Re – Planning Application DM/26/1377 Proposal for 9 new build homes. Land At Mill Lane Sayers Common West Sussex

Figure 3: Direction of flow of water along ditch by footpath

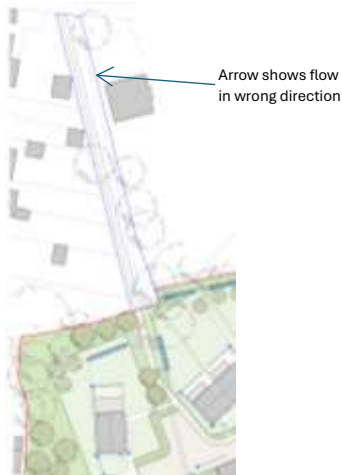
6. In all the plans, and specifically in “1795_3.040_RevB_Surface Water Drainage Strategy Plan” The water flow direction on the ditch along old footpath is shown in the wrong direction. The slope drops towards Oakhurst Road. As this frequently floods at the Oakhurst Road end, blocking the footpath along Oakhurst Road, its direction, and any mitigation to avoid such flooding is clearly important. (See Figure 3)

Figure 4: Location of garages which interrupt vegetation ribbon

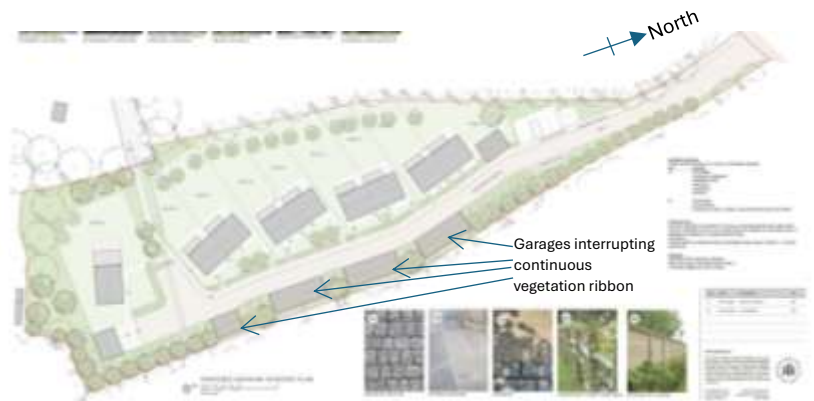
9. In the Design & Access Statement it states: "Continuous vegetation ribbon to surround site to encourage sustainable biodiversity." This seems incompatible with the plan showing garages on the eastern side of the site adjacent to the A23. (See Figure 4)
10. In the Design & Access Statement section 6.04 it states: "Dense planting of native hedging to Western and Northern boundary." But there is no north boundary except the vehicle entrance, so I am a little confused as to what this can mean. (See Figure 4 for direction of north)
11. In the 1795_Planning Statement, section 4.7, it is stated that the Church is a Grade II Listed building. This is not the case, and it seems surprising that such a simple fact can be incorrect in such a key document. It is instead a non-designated historical and community asset.
